APPLICATION NO.	FILING DATE	FIRST NAMED INVENTOR	ATTORNEY DOCKET NO.	CONFIRMATION NO.
10/575,730	12/21/2006	Artur Grunwald	GKNG 1282 PCT	4609
²⁷²⁵⁶ Dickinson Wrig	7590 09/03/200 ht PLLC	EXAMINER		
38525 Woodwa		LIGERAKIS, JOHN		
Suite 2000 Bloomfield Hills, MI 48304			ART UNIT	PAPER NUMBER
			3681	
			MAIL DATE	DELIVERY MODE
			09/03/2008	PAPER

Application No.	Applicant(s)			
	10/575,730	GRUNWALD ET AL.			
Office Action Summary	Examiner	Art Unit			
	John V. Ligerakis	3681			
The MAILING DATE of this communication app Period for Reply	ears on the cover sheet with the c	orrespondence address			
A SHORTENED STATUTORY PERIOD FOR REPLY WHICHEVER IS LONGER, FROM THE MAILING DA - Extensions of time may be available under the provisions of 37 CFR 1.13 after SIX (6) MONTHS from the mailing date of this communication. - If NO period for reply is specified above, the maximum statutory period w - Failure to reply within the set or extended period for reply will, by statute, Any reply received by the Office later than three months after the mailing earned patent term adjustment. See 37 CFR 1.704(b).	ATE OF THIS COMMUNICATION 36(a). In no event, however, may a reply be tin will apply and will e

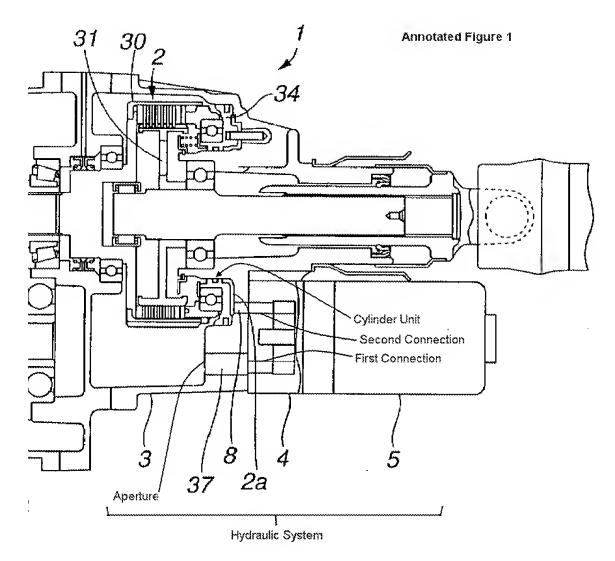
Claims 15-21, 34, and 35 are rejected under 35 U.S.C. 102(e) as being anticipated by Sakata et al. (US 2003/0230461). Regarding claims 15 and 16, Sakata et al. discloses (See Annotated Figure 1) an axial setting device (1) for actuating a multi-plate coupling (2) in the driveline of a motor vehicle, comprising: a housing (3) in which there are supported two parts (30,31) so as to be coaxially rotatable relative to one another, which two parts (30,31) can be coupled to one another by the multi-plate coupling (2) arranged in the housing (3); a cylinder unit with a hydraulic chamber (2a) and a piston (34) which is arranged in the hydraulic chamber (2a) so as to be axially displaceable and which is provided for actuating the multi-plate coupling (2); and a hydraulic system for supplying the cylinder unit, comprising a quantity of oil jointly contained in the housing (3) and in the hydraulic chamber (2a), and a pump (4) having a first connection connected to the housing (3) and a second connection connected to the hydraulic chamber (2a), wherein the pump (4) is adapted to convey oil from the housing (3) to the hydraulic chamber (2a) and vice versa.

Regarding claims 17 and 18, Sakata et al. discloses an axial setting device as set forth above, wherein the pump (4) is firmly connected to the housing (3), and in the housing (3), there is provided an aperture connecting the first connection to an interior of the housing (3) and a channel (8) connecting the second connection to the hydraulic chamber (2a).

Regarding Claims 19 and 20, Sakata et al. discloses an axial setting device as set forth above, comprising an antechamber (37) in the housing (3) between the aperture and the first connection.

Regarding Claim 21, Sakata et al. discloses an axial setting device as set forth above, wherein the channel (8) is provided in the housing (3) only.

Regarding Claim 34, Sakata et al. discloses an axial setting device as set forth above, wherein the pump (4) can be driven by an electric motor (5) and is controllable (See Fig. 1) by an electronic control unit (7).

Regarding claim 35, Sakata et al. discloses an axial setting device as set forth above, wherein the pump (4) and the electric motor (5) form one unit and are positioned on a common longitudinal axis.
